**Sent:** 1/02/2021 10:35:21 AM  
**Subject:** Submission - DA for 11 Lewis Street Balgowlah Heights (DA 1758/2020)  
**Attachments:** Submission DA 11 Lewis St Balgowlah Heights January 2021.pdf;

**Re: 11 Lewis Street, Balgowlah Heights (DA 1758/2020)**

I write in response to the notification of the above Development Application (DA) and raise **strong objection**, on behalf of my clients, Jaxon and Clare Rudduck, owners of No. 26 Lewis Street, immediately opposite the site, to the east.

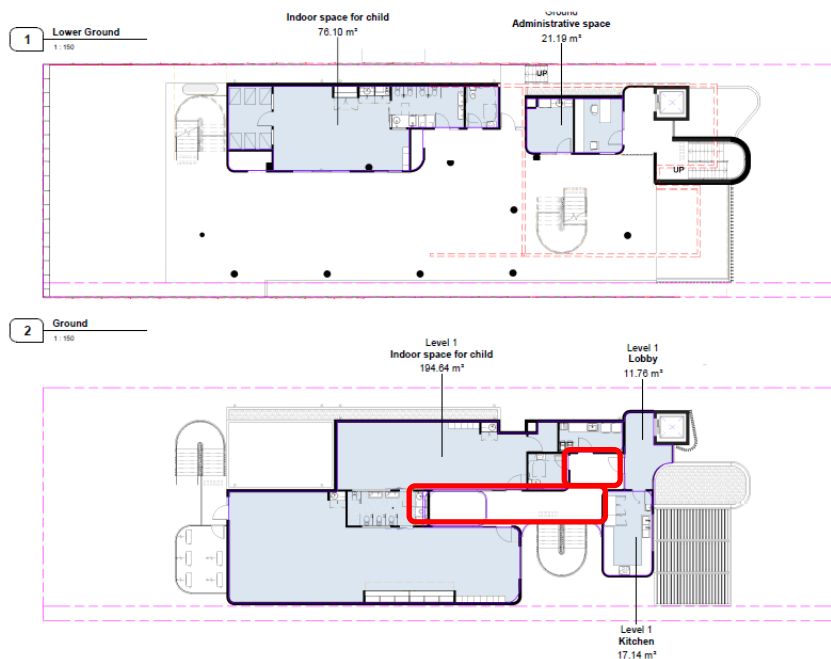
The key words and consideration are a "low density" residential environment. While the proposal (arguably) complies with the FSR standard, the scale and intensity of the proposal is inconsistent with the surrounding low density area. The bulk is excessive, exacerbated by areas not included in GFA calculations. The number of children is high and the parking and excavation is also not consistent with a low density residential area.

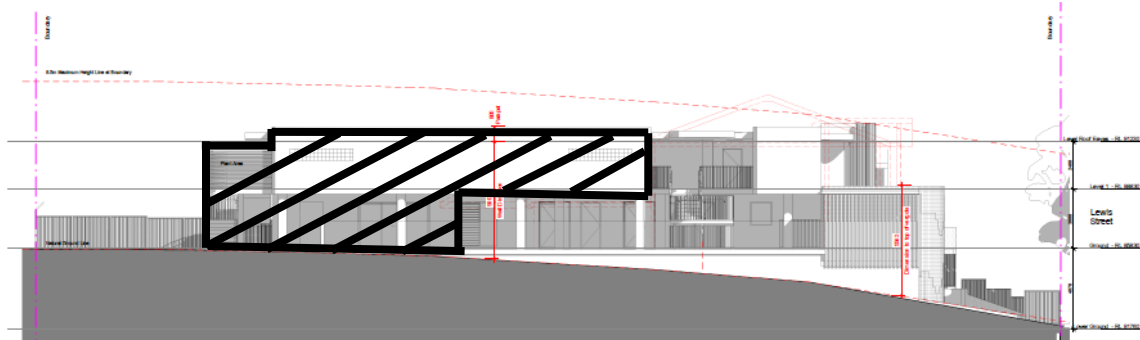
Like the FSR, the proposal is within the numerical maximum, although distributes its height and bulk deep into the site, contrary and inconsistent with neighbouring and prevailing development within the area. The rear bulk is well westward of surrounding adjoining development and the predominant rear building line. Also, unlike surrounding residential development, the building does not “step down” to the rear, adding to visual, privacy and bulk impacts. The non-compliant side setbacks also exacerbate perceived bulk and height.

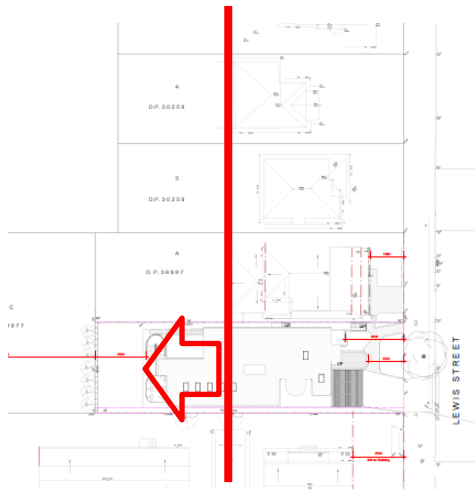
The excessive scale and bulk are shown by:

- (a) The proposal extending well past the predominant rear building alignment. This rear alignment is shown in the aerial photo below:

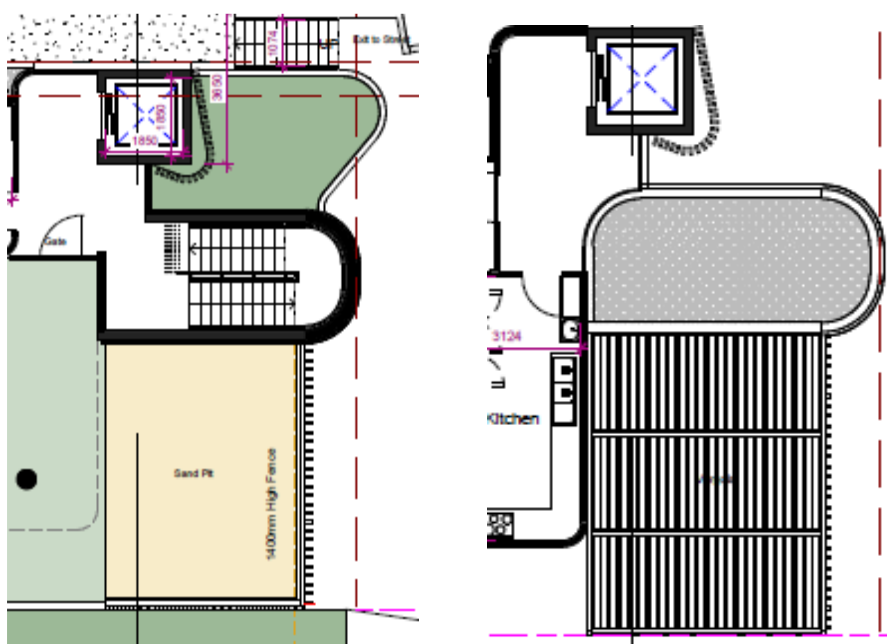
- a) A ground floor dominated by a carpark entry, stair enclosure and small entry (with limited surveillance or gathering space):

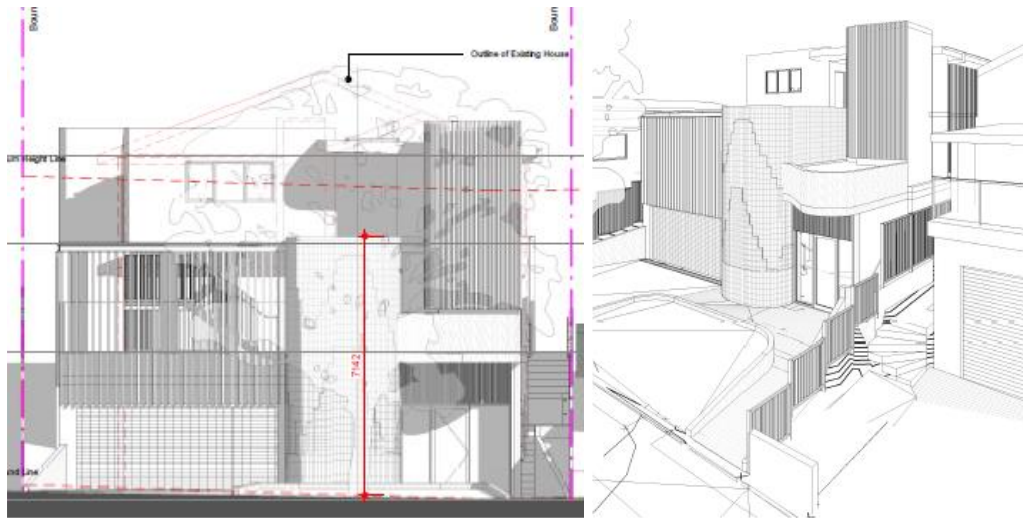
- b) A first and second floor above dominated by screening and inactive uses, concealing an undercroft area, with a lack of surveillance or engagement with the streetscape, given the recessed upper kitchen window:
